Michigan Avenue & Irving Street NE Mixed Use Complex | Phase 1 & 2

Planned Unit Development
Amended Phase 1 Consolidated Application
June 25, 2015

CASE NO. 08-33C

Changes Reflected in Amended PUD Drawings

Approved Garage North Elevation

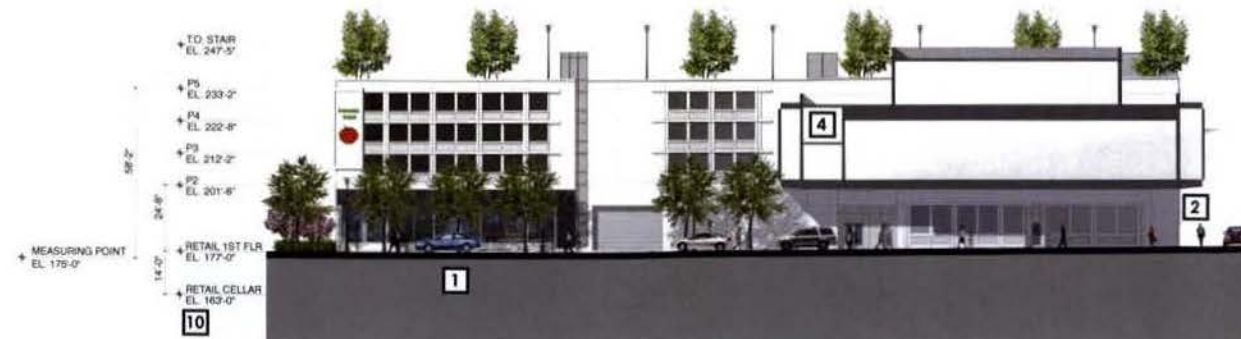
- 1** Increased height of retail space
- 2** Increased height of conference center ballroom level, added storefront windows at ground floor, and eliminated columns under conference center to improve pedestrian experience and view corridors for future phase 2 retail
- 4** Incorporated roof terrace level into conference center
- 10** Added cellar parking in garage and extended footprint to edge of hotel to provide more parking spaces within the parking structure
